Flexcity Belgium NV
F. Demetskaai 52
1070 Brussels

Subject: Flexcity's view on the Formal public consultation on Terms and Conditions for balancing service providers for Automatic Frequency Restoration Reserve (aFRR)

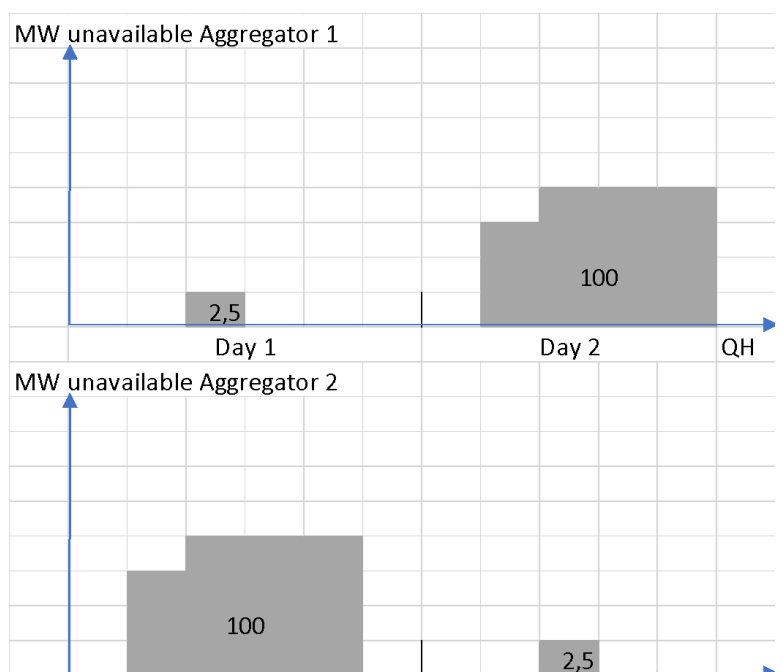
Suppose two aggregators which have reported the outages as indicated in the figure to the right. Both reported two non-compliant CCTU's on two consecutive days. Both aggregators reported exactly the same "MW_{not made available}" for those CCTU's: 2.5MW/h and 100MW/h however in the opposite order for both aggregators.

If we now calculate the penalty for both aggregators (PaFRR Made Available) with CP_{WA} of 3.5€/MW/h (see table below) we find that

the aggregator 1 needs to pay almost double of aggregator 2 despite having an identical unavailable volume and an identical number of non-compliant CCTU's.

The difference caused by the non-linearity cannot be interpreted as fair to Aggregator 1.

Flexcity would like to refer to their response to the mFRR consultation in which a counter proposal was made for this specific penalty.

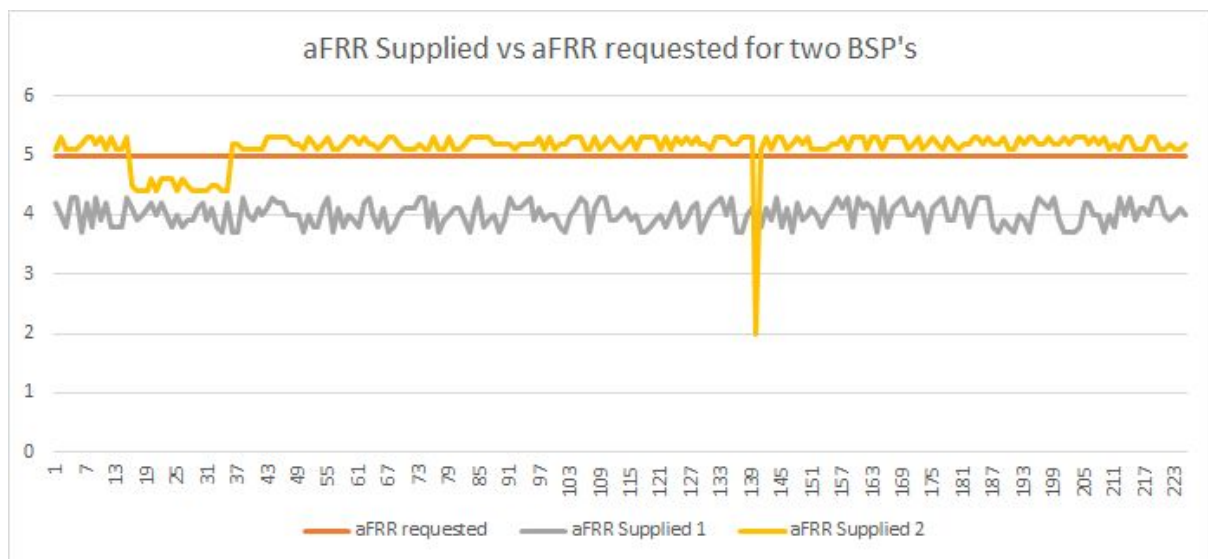
In the currently proposed penalty scheme a penalty would be due if, during at least 15 time steps, the aFRR supplied is lower than the aFRR requested (in the case of aFRR UP).

The “aFRR Missing MW” is a crucial parameter in the determination of penalty for the aFRR missing MW. It is defined as the **highest** deviation between requested and supplied aFRR. In the next graph we show a full availability test (with the 225 timesteps of QH2 of the test) for two BSP’s who both had to supply 5MW of aFRR

- BSP 1 has consistently supplied around 4MW, strongly suggesting that this BSP is technically not capable to deliver the volume they sold to ELIA. the aFRR missing MW is 1.3MW
- BSP 2 has 20 timesteps in which the aFRR requested was not reached. One of those 20 timesteps is an outlier in which the delivered aFRR decreased to 2 MW. the aFRR missing is therefore 2MW

When the selection and selection prices of both BSP’s is similar BSP 2 will pay 154% the penalty of BSP 1 despite they are clearly delivering a better quality service as BSP 1. The outlier which affected BSP 1 could cost them up to 60% of the revenues of the last 30 days while, if the outlier was ignored, the cost would have been drastically reduced. Outliers can never be avoided and the risk that an outlier would lead to a considerable penalty cannot be ignored with this set-up.

One possibility to resolve this issue would be to take a percentile of the deviation per timestep instead of the highest . For example: if we take the 90st percentile of the deviation (meaning 90% of deviations are smaller) this would give for BSP 1.3MW as aFRR missing MW, exactly the same as before. For BSP 2 the 90st percentile is 0,6MW, effectively ignoring the outlier and leading to a penalty which seems more correct as compared to the performance of BSP 1.
